KX125-K1 ENGINE OUTPUT SHAFT COLLAR		MC 93-06 August 27, 1993
---	--	---	------------------------------------

FACTORY DIRECTED MODIFICATION

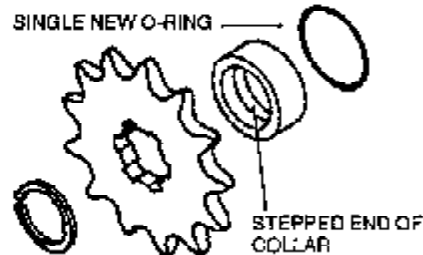
- Support the motorcycle on a suitable stand.
- Remove the engine sprocket cover.
- Take off the circlip and slip the engine sprocket off the transmission output shaft.
- Slide the collar off the output shaft, and inspect it for cracks.
- ★ If the collar is cracked or damaged in any way, replace it.
- Remove the two O-rings from the output shaft with a pick or a scribe and discard them.

- Be sure to use a single new O-ring only. Do not reuse the O-rings removed or try to use two of the new o-rings.
- The collar must go on the counter shaft with the stepped end toward the crankcase.

- Be sure the circlip is properly installed in the groove in the transmission output shaft.
